AGENDA
ZONING BOARD OF ADJUSTMENT
REGULAR MEETING
4:00 P.M., Wednesday, June 6, 2018
City Council Chambers, 2nd Floor of City Hall
823, Rosenberg, Galveston, Texas

STAFF REPORT

18Z-011

Re: **ZBA Variance Application**
Hilton Garden Inn – Seawall Blvd and 77th St.
7627 Stewart Rd.

A5.03

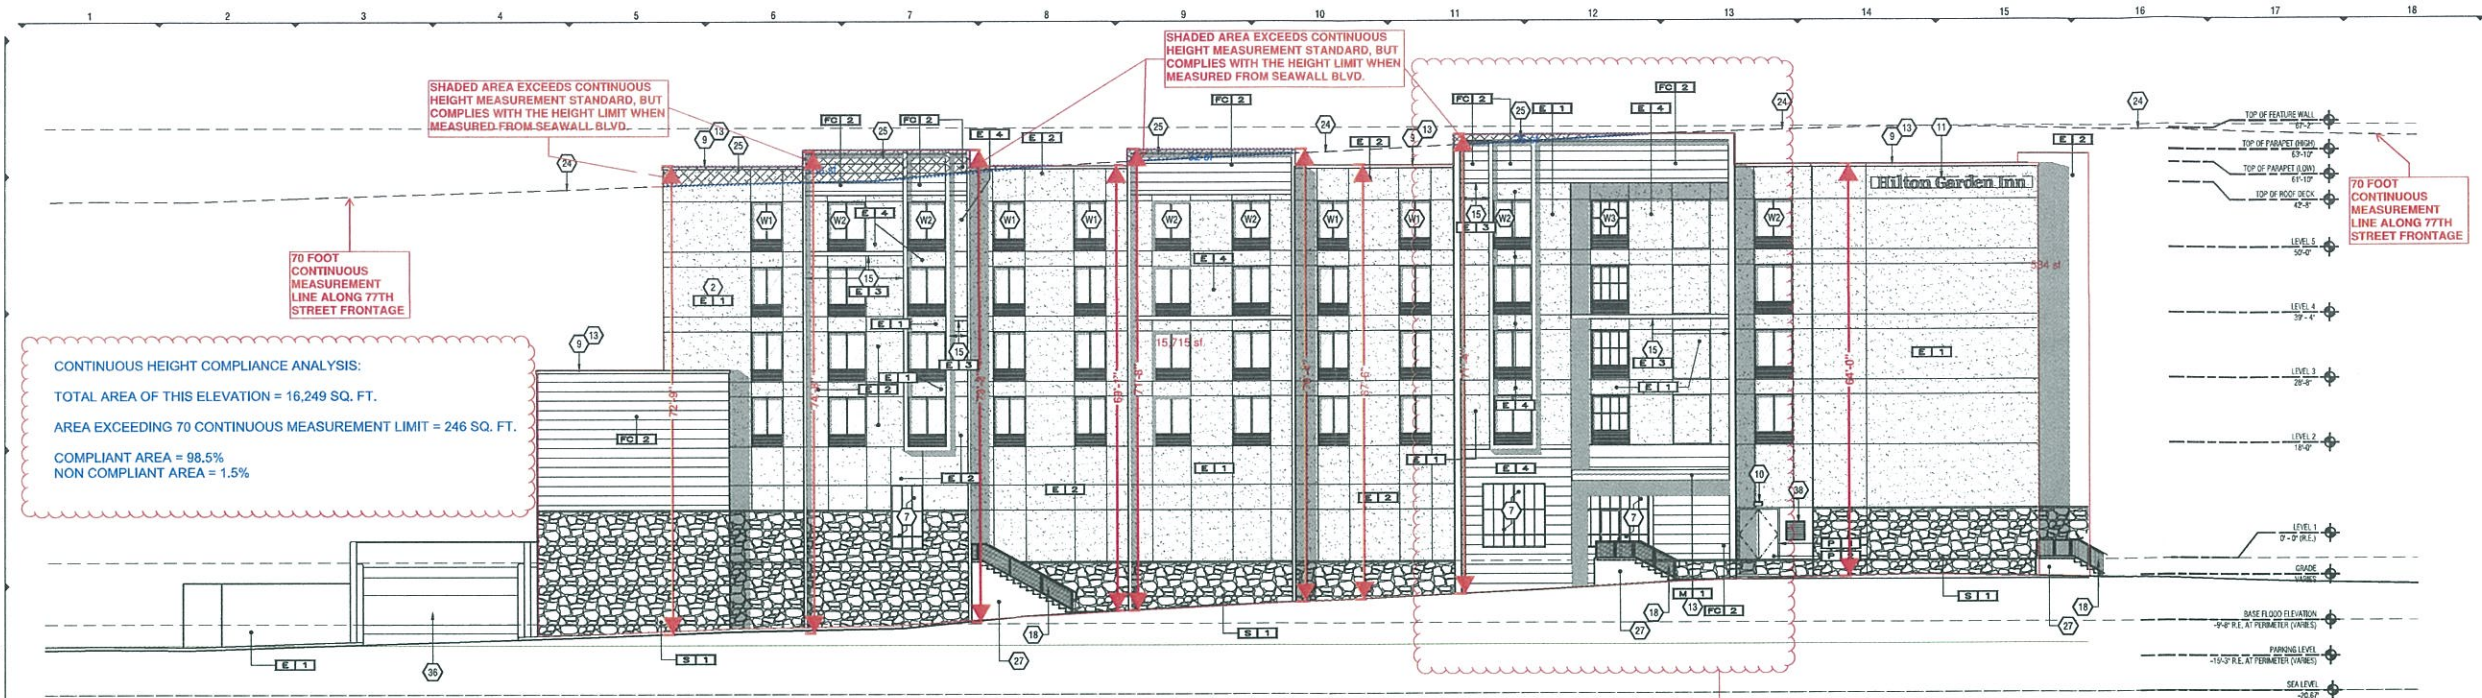
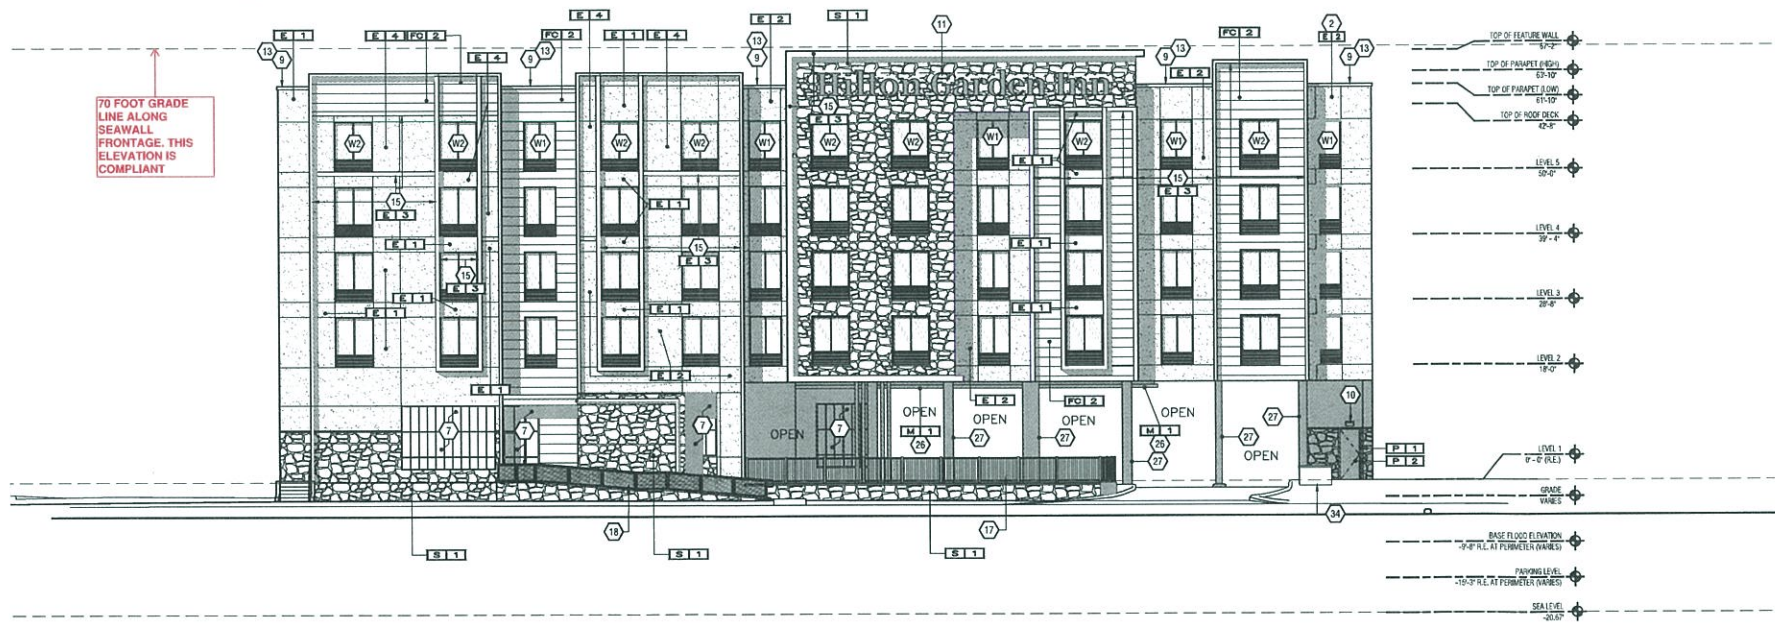
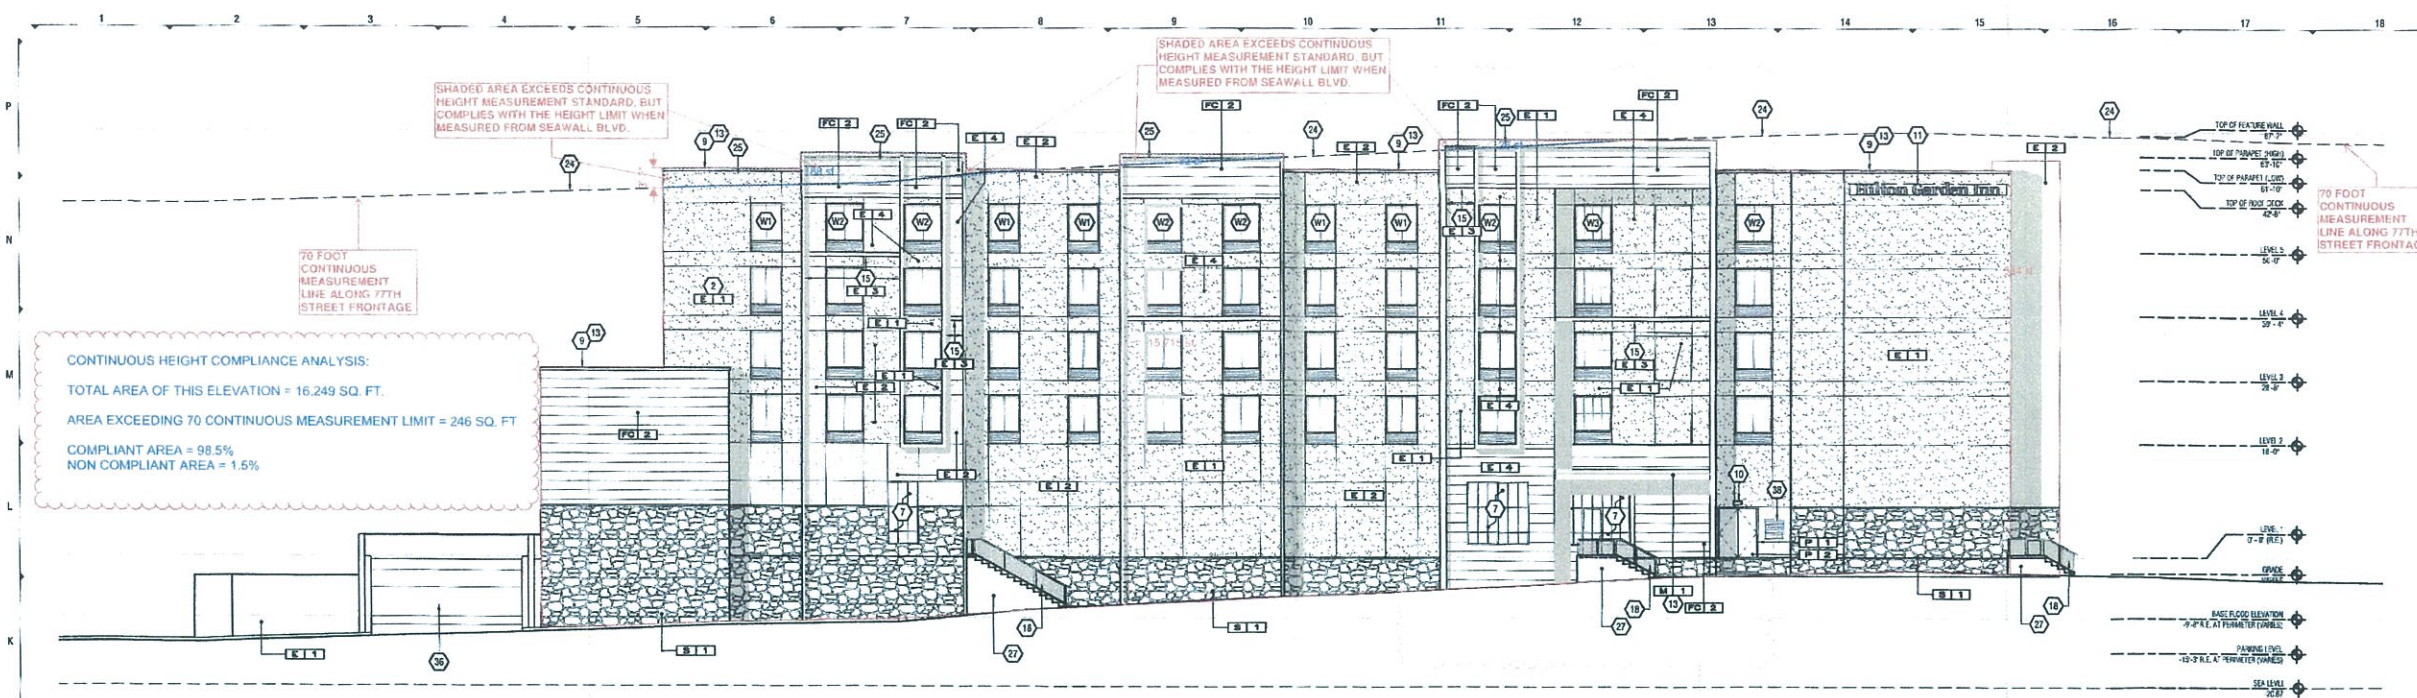
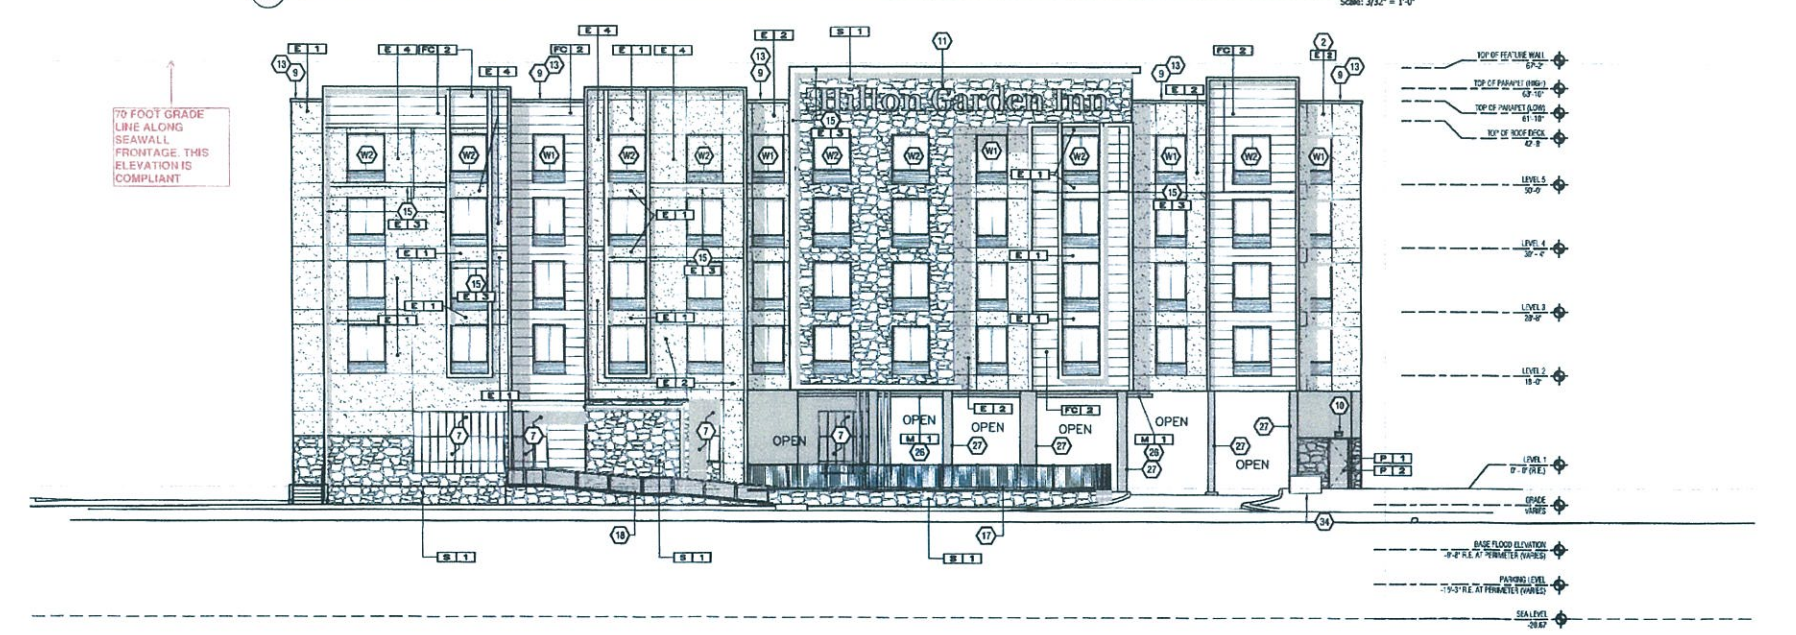
The applicant is requesting a variance from height along the north and west sides of the proposed Hotel shown in Exhibit B pages A5.02 and A5.03. The red arrows indicate the height in specific areas along those sides of the hotel due to the grade change. The highest point of the building is proposed to be 74-feet, 8-inches from grade.

Height - From 70-feet to 74-feet 8-inches
